To:	All plan holders	From:	Tracy Bruun, Division
Pages:	25, including this cover sheet	Phone:	515-344-6279
Re:	Sto852118B Nutrient Reduction Wetland (Bid 24-07)	Date:	December 31, 2024

Subject: **Addendum No. 1** to Bid Documents
STO852118B Nutrient Reduction Wetland Project – Bid No. 24-07
Story County, Iowa

IDALS WATER RESOURCES BUREAU
HENDERSON - PROJECT NO. ST0852118B

SHEET
M.03

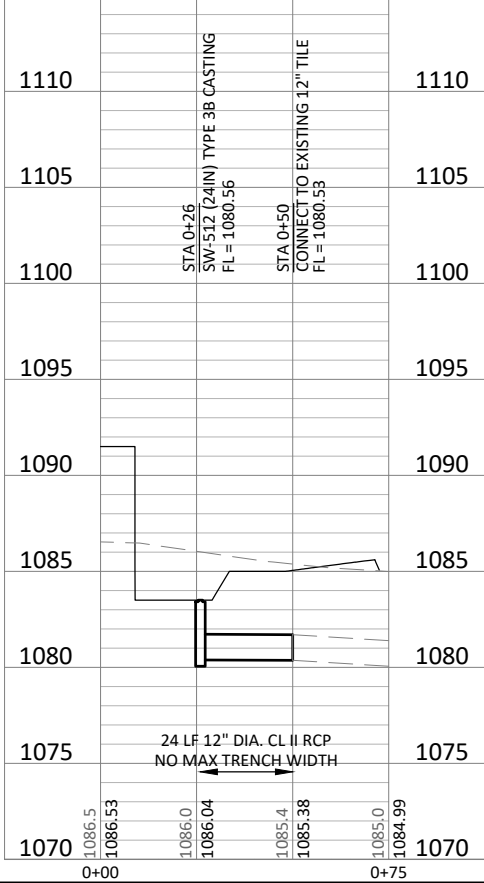
3. An intake within the stilling basin and connection to the existing tile will be added. This will be an SW-512 area intake structure and 24 LF of 12" RCP.

- Modifying Bid Item No. 5 “Reinforced Concrete Pipe” into “5A” for 12-inch diameter and “5B” for 15-inch diameter.
- Adding new Bid Item # 28 “SW-512 Area Intake”.
